Title - Sujet UV Treatment System Installation	
Solicitation No. - N° de l'invitation F1700-180019/A	Amendment No. - N° modif. 007
Client Reference No. - N° de référence du client F1700-180019	Date 2019-01-14
GETS Reference No. - N° de référence de SEAG PW-\$PWY-019-8504	
File No. - N° de dossier PWY-8-41167 (019)	CCC No./N° CCC - FMS No./N° VME
Solicitation Closes - L'invitation prend fin at - à 02:00 PM on - le 2019-01-18	
F.O.B. - F.A.B. Plant-Usine: <input type="checkbox"/> Destination: <input checked="" type="checkbox"/> Other-Autre: <input type="checkbox"/>	
Address Enquiries to: - Adresser toutes questions à: Ngan, Ken (PWY)	Buyer Id - Id de l'acheteur pwy019
Telephone No. - N° de téléphone (604) 671-0219 ()	FAX No. - N° de FAX (604) 775-6633
Destination - of Goods, Services, and Construction: Destination - des biens, services et construction: DFO - West Vancouver Laboratories - West Vancouver, BC

This Solicitation Amendment 007 is raised to incorporate Addendum 2.

F1700-180019/A – UV Treatment System Installation – Tender Questions – Addendum 2

Figure C-3D
West Vancouver Laboratory
Exceedances - Hydrocarbons
in Soil (incl Historical)

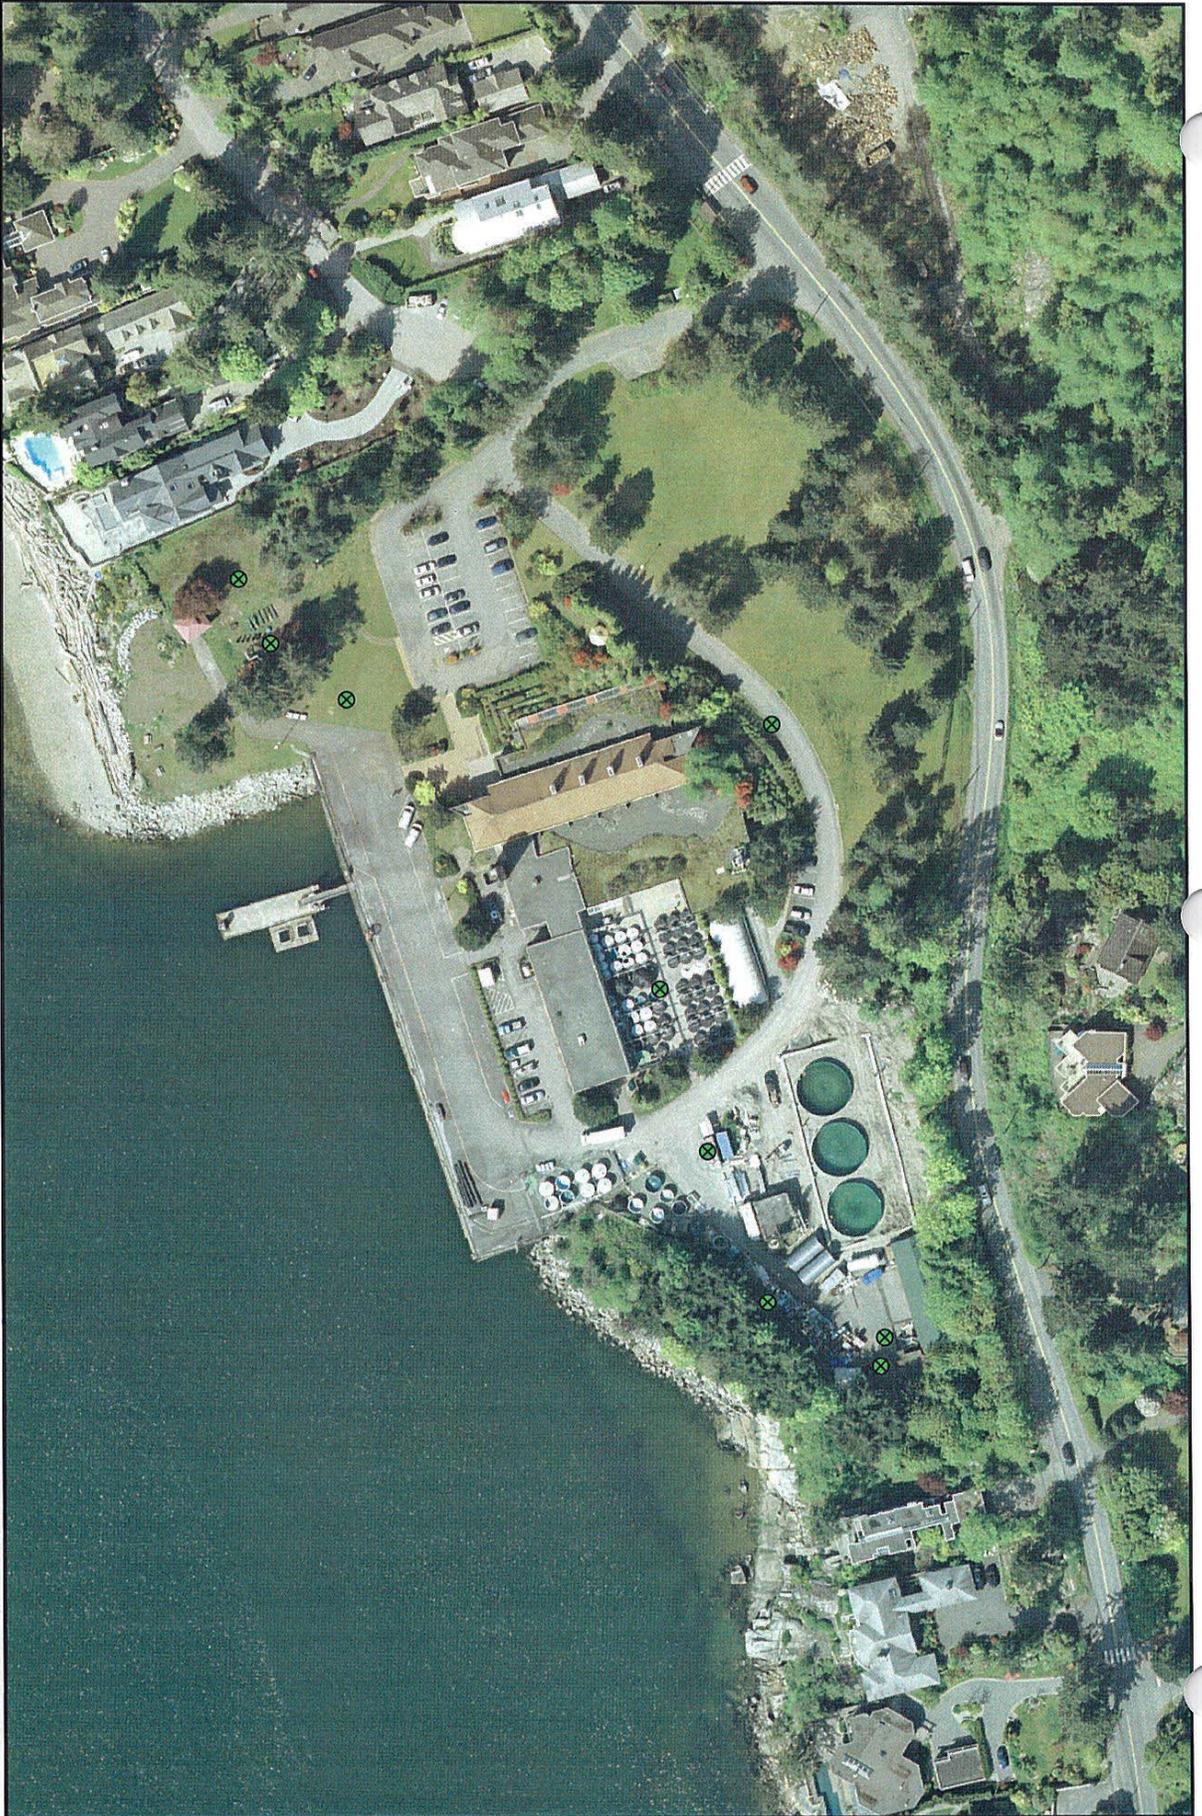
5. Q. We have been told by civil contractor that the soil is contaminated. Are we going to remove the soil from site and just leave the soil on site?
- A. Soil and groundwater testing has been conducted in 2007 as part of a site wide assessment and risk management program. A figure attached shows surface and subsurface sampling for soil at the site for metals (Figure C3E and hydrocarbons figure C-3D). The limited sampling conducted in the areas identified for trenching and subsurface works do not indicate an exceedance for metals or hydrocarbons. It would be the contractors responsibility to ensure soil quality is acceptable for disposal. The contractor should assume the soil meets the CSR and CCME standards for Commercial soils. If new testing indicates it exceeds these parameters the contractor would be permitted to submit a change order request for the cost differential.
